**Knox Planning Scheme Amendment C184knox and Permit
Application P/2020/6049
Former Norvel Road Quarry, Ferntree Gully**

Panel Report

14 May 2024

Figure 2 Rezoning proposal

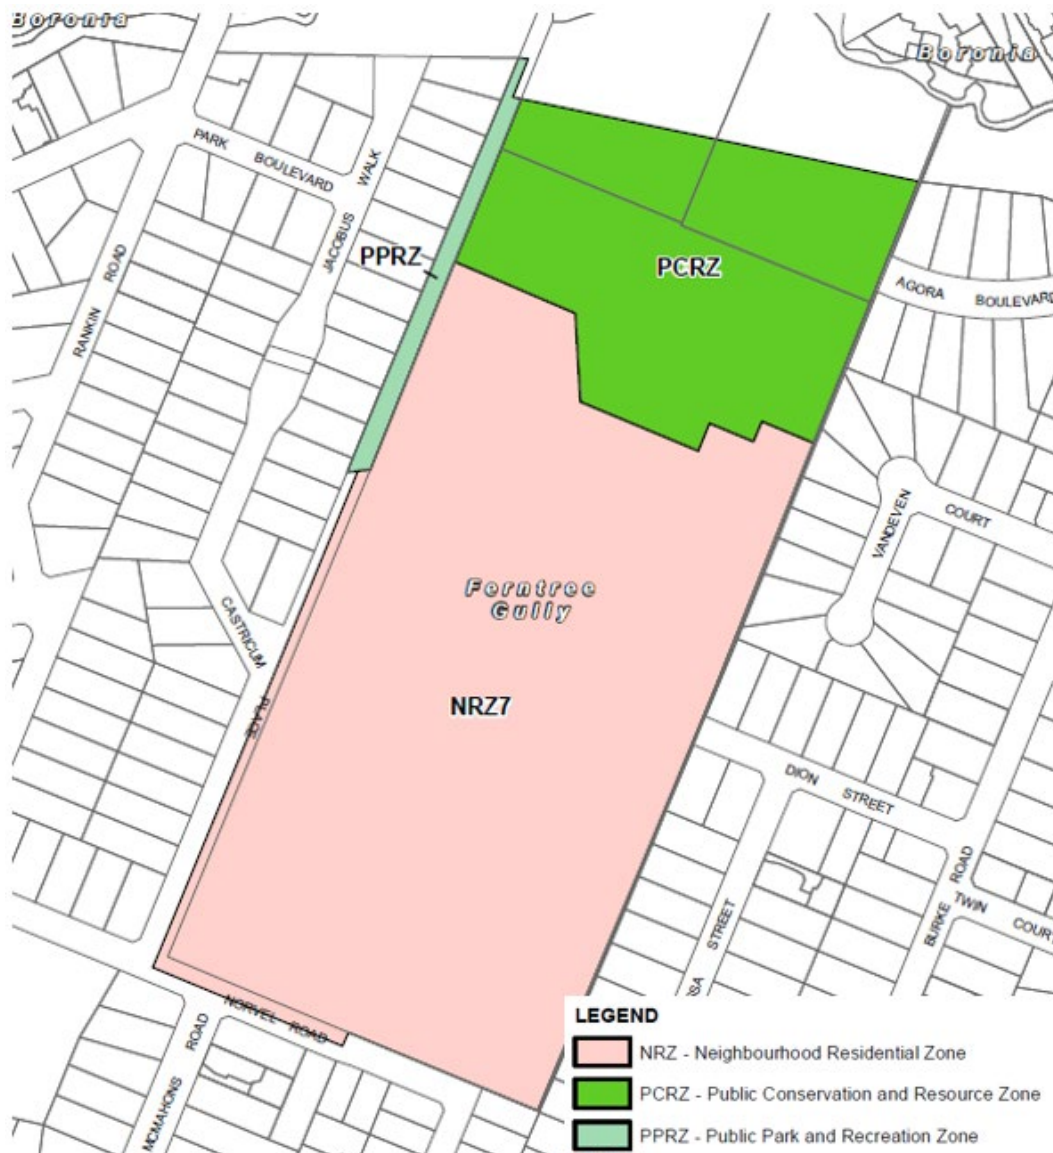
The Amendment proposes to amend the Knox Planning Scheme (Planning Scheme) to:

- rezone land from the Special Use Zone Schedule 2 – Earth and Energy Resources Industry (SUZ2) to Neighbourhood Residential Zone Schedule 7 – Norvel Estate (NRZ7)
- rezone the existing bushland from SUZ2 to the Public Conservation and Resource Zone (PCRZ)
- rezone the abutting linear reserve from part SUZ2 and part Neighbourhood Residential Zone Schedule 4 to Public Park and Recreation Zone (PPRZ)
- rezone part of the Castaicum Place, Seecal Road, and Norvel Road reserves from SUZ2 to NRZ7
- amend Clause 22.07 Development in Residential Areas and Neighbourhood Character to exempt the NRZ7 from Clause 22.07
- amend Planning Scheme Map 2 to reflect the rezoning.

Figure 7 Seecal Road Reserve

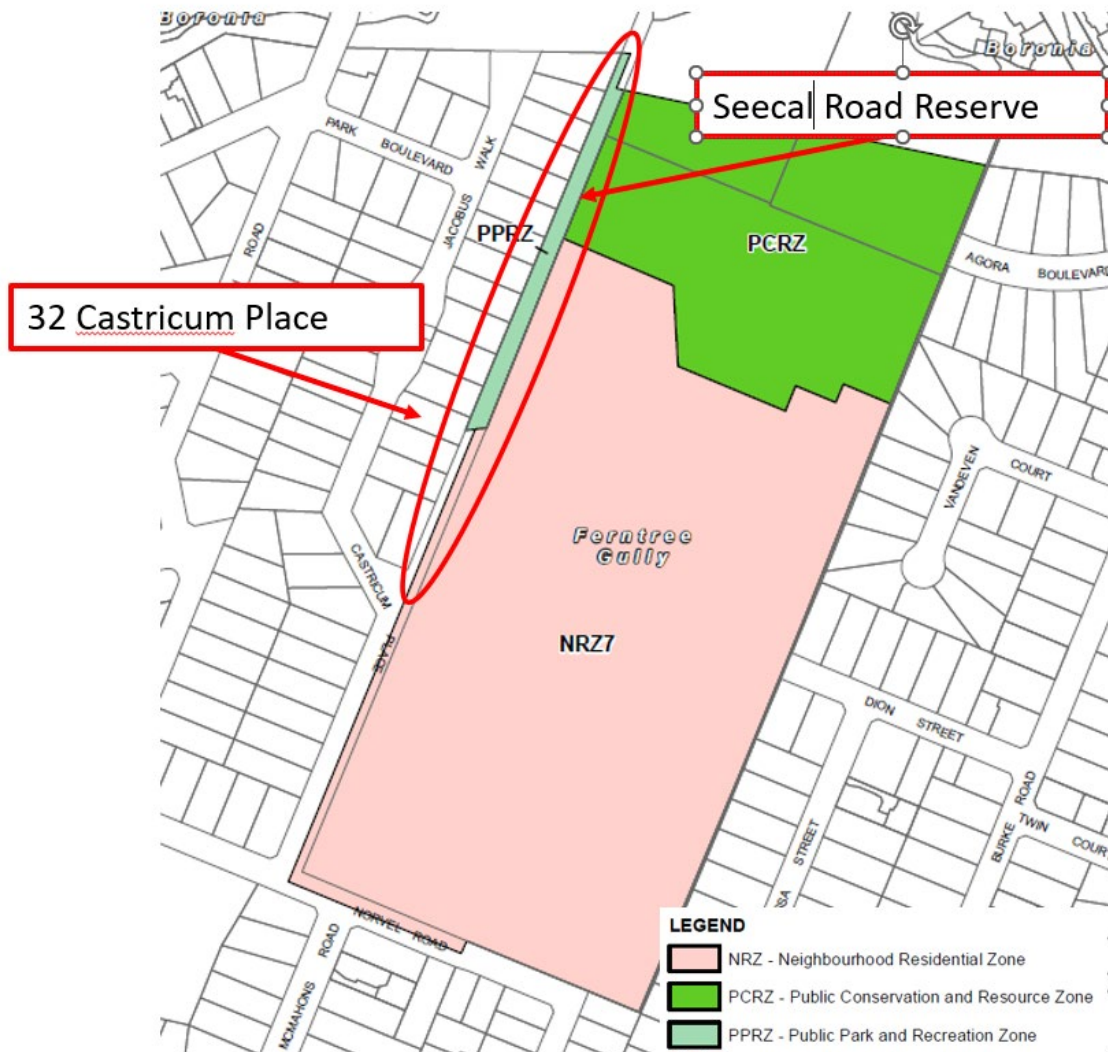
The Amendment proposes to rezone part of the Seecal Road Reserve (approximately north of 32 Castricum Place) to the Public Park and Recreation Zone, while the remaining part of the land will be rezoned to the Neighbourhood Residential Zone – Schedule 7.

Friends of Blind Creek Billabong questioned why part of Seecal Road would remain in residential zoning and why all of Seecal Road Reserve would not be rezoned PPRZ. It said:

Further, the rezoning of the southern part of the Seecal Road Reserve to PPRZ was not exhibited with the Amendment, and would be subject to a separate planning scheme amendment process.

Figure 10 Impacted native vegetation

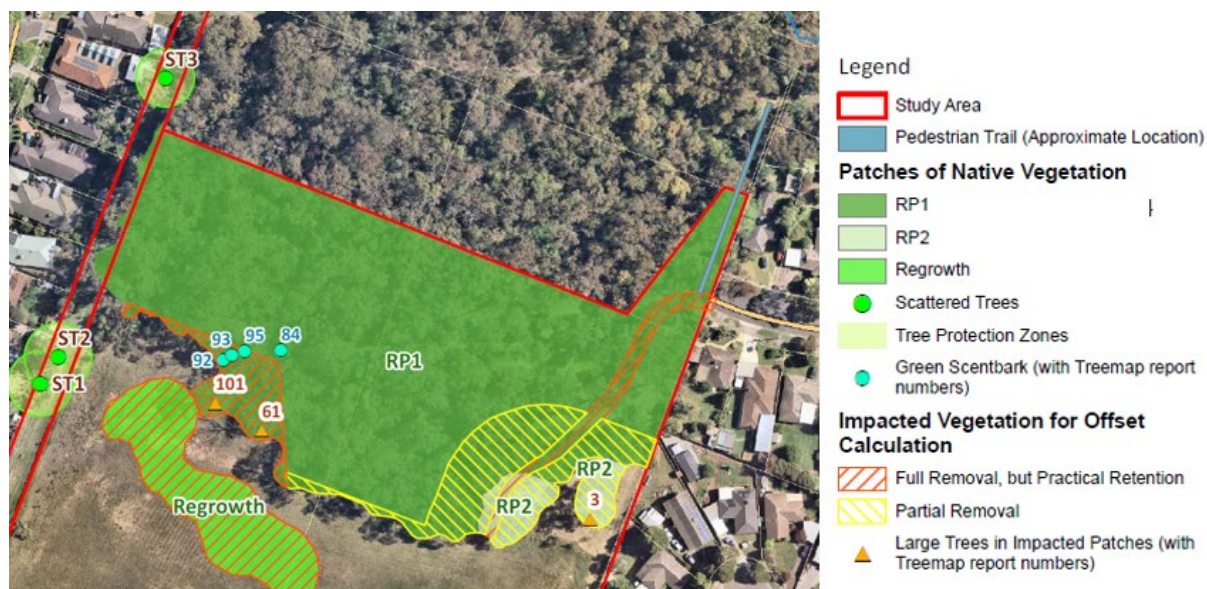
The Biodiversity Assessment included a plan showing the patches of remnant vegetation and impacted vegetation (see Figure 10 showing the 2023 version with pedestrian trail included). The Biodiversity Assessment concluded:

Only a relatively small proportion of RP1 [Remnant Patch 1] and RP2 [Remnant Patch 2], within the study area, will require vegetation removal for the proposed development. Three scattered indigenous trees were also recorded in an area that may support a trail to connect the development to Blind Creek and a sewer, but these trees are unlikely to require removal through sensitive design of these elements.

Figure 11 Boardwalk/pathway - Landscape Masterplan drawings 01 and 02 (17/02/21)

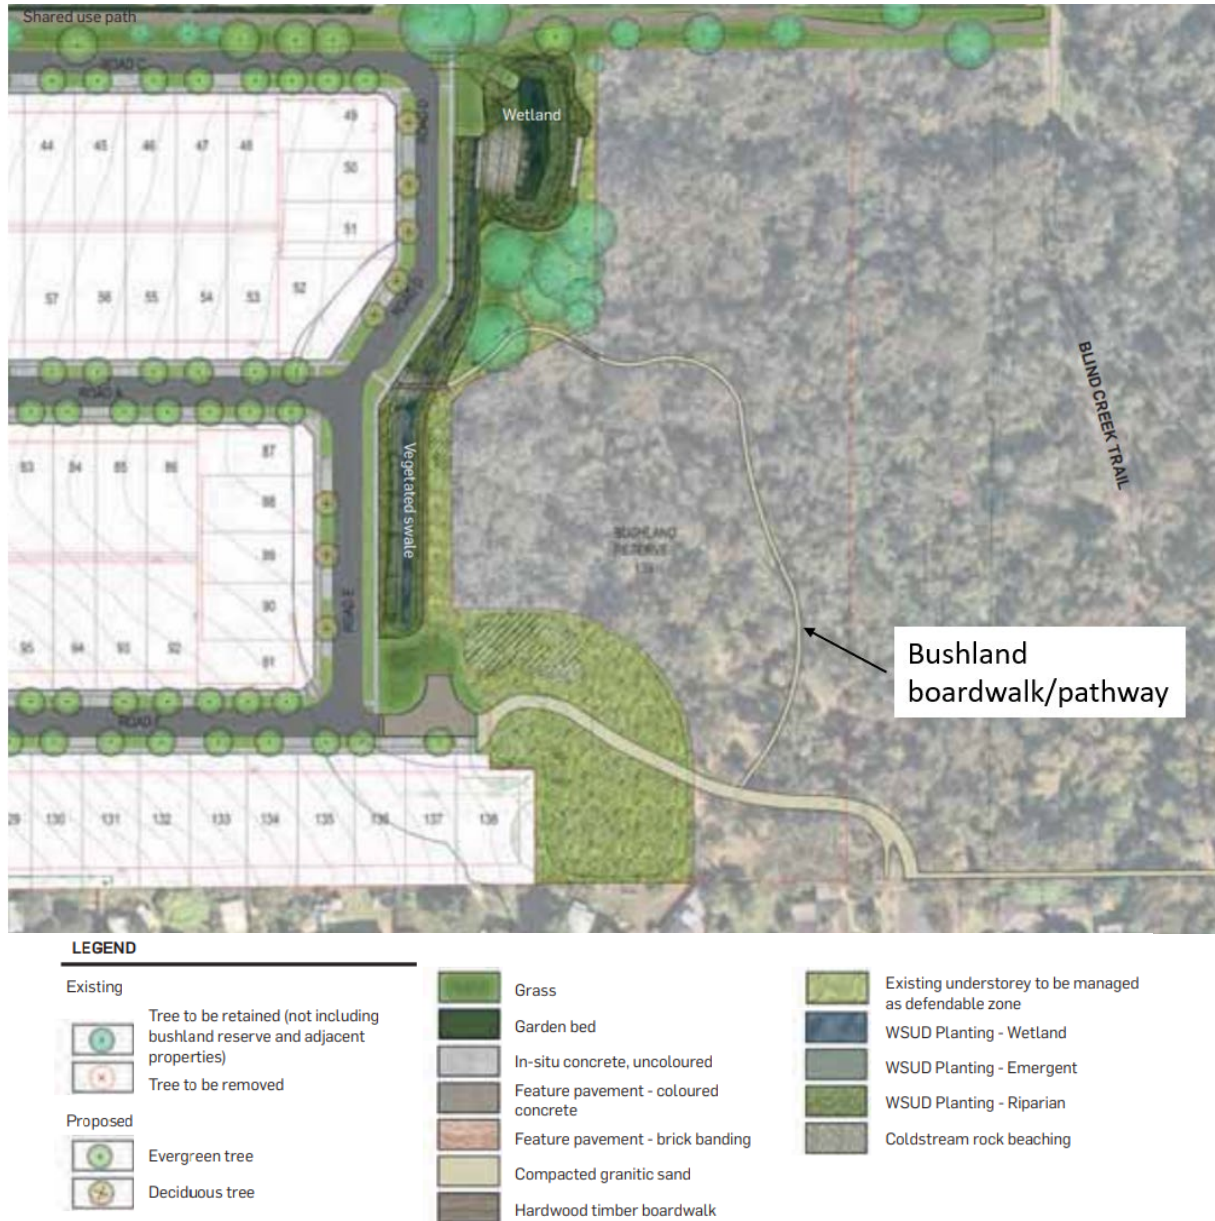
- it intended to provide for some flexibility on the design specifications for the boardwalk/pathway, to enable a contribution to be determined
- the plan referred to in the condition was tabled at the Council meeting on 22 November 2021 (see Figure 11)
- importantly the indicative location of the boardwalk/pathway had previously been contemplated but was removed prior to exhibition as it was not captured in the Cultural Heritage Management Plan (CHMP)
- the intent of the condition is to capture the design and location of both the boardwalk/pathway and signage.

The Proponent generally agreed with Council's conditions, however in commenting on the final day version of the planning permit it proposed a new condition to update the Biodiversity

Assessment to assess additional native vegetation for removal (if any) to accommodate the bushland boardwalk/pathway and to assess native vegetation offsets.

- 9) Prior to the issue of a Statement of Compliance for Stage 1, concurrently with the submission of plans for endorsement under Condition 1, a plan must be prepared to the satisfaction of the Responsible Authority and be generally in accordance with the **landscape masterplan drawings 01 and 02 prepared by Urbis dated 17/02/21** (Job No. ND1757)

Figure 12 Subdivision Master Plan (exhibited) – Lot 138 and TPZ

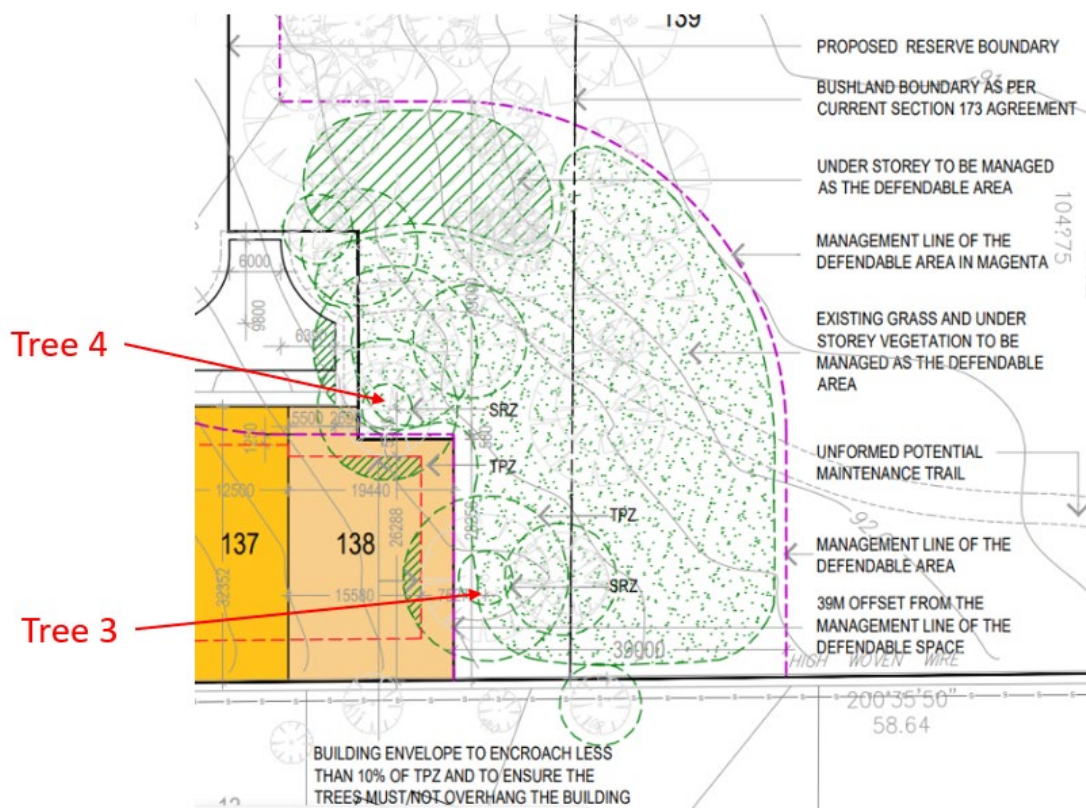
No trees are proposed to be removed to accommodate Lots 136, 137 and 138. According to the Arborist Report:

- the building envelope of Lot 138 is within the TPZ for two existing trees (Trees 3 and 4) (see Figure 12)
- Trees 3 and 4 are suitable to be retained and should be retained
- the encroachment from the building footprint for each tree is less than 10 per cent of the TPZ, which is minor and acceptable.

Figure 15 Flood levels – Jacobus Walk

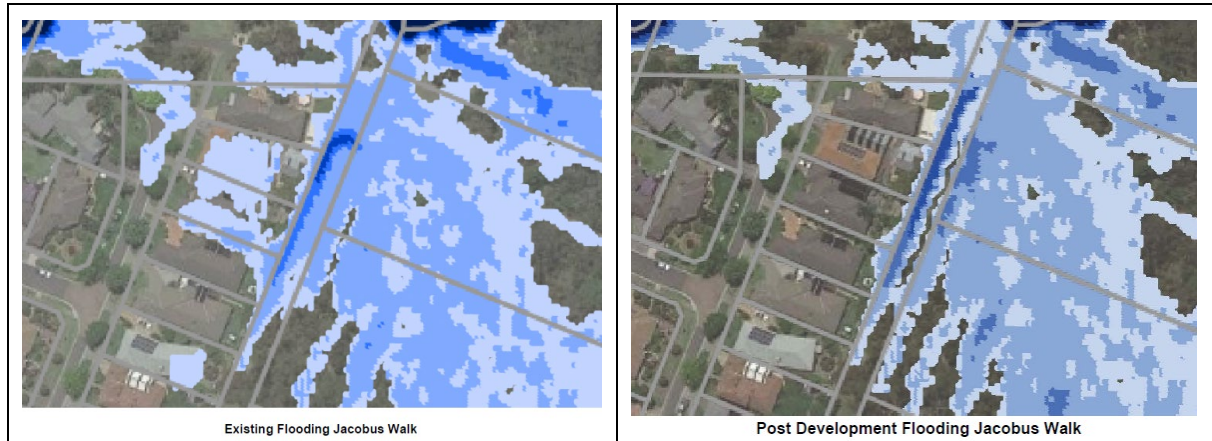
Mr Glasson relied on the Cardno flood modelling to show the flooding affecting the Jacobus Walk properties. A submitter said the flooding extends further south from that shown in the modelling. Mr Glasson said the development of the site in accordance with the Stormwater Management Plan will alleviate any existing flooding on properties adjacent to the site, as shown in the pre and post development flood depth maps (see Figure 15 below).

Council was satisfied that the development will improve flood impacts along the Seecal Road Reserve and properties to Jacobus Walk, noting that permit conditions require approval of further detailed design of the proposed drainage and stormwater treatments. It submitted that the Stormwater Management Plan recommends that this flooding can be reduced by:

Figure 17 Lot 52 location and context

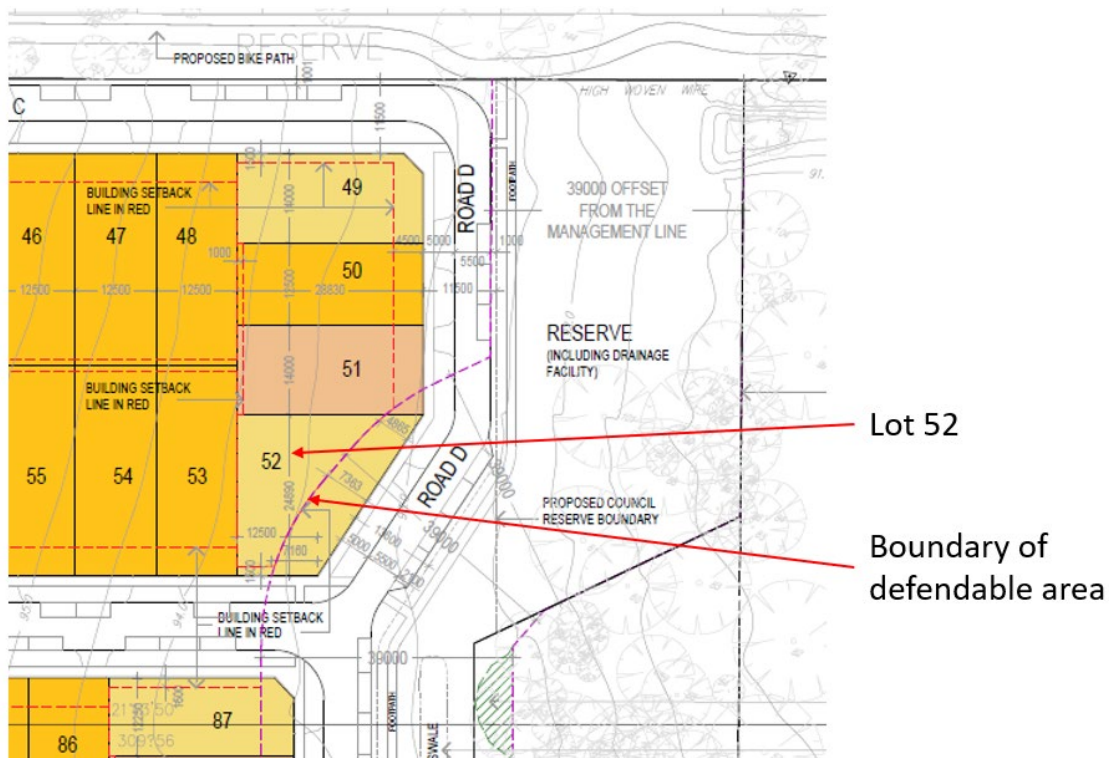
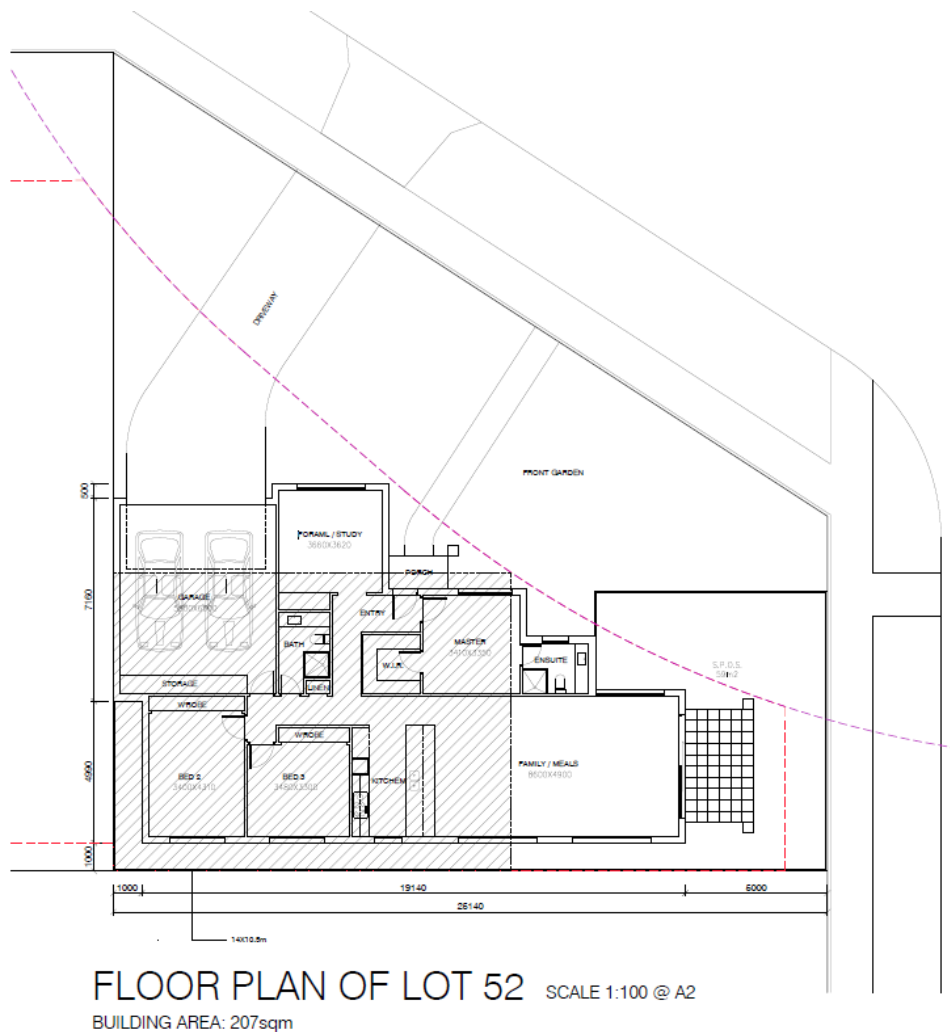
(i) Lot 52 build envelope, rear setback and landscaping - exhibited conditions 1)a)i), 20)d) and 20)k)

Figure 17 shows the location and context of Lot 52, including the boundary of defendable area for bushfire management purposes. Figure 18 shows an indicative floor plan for Lot 52 submitted by the Proponent.
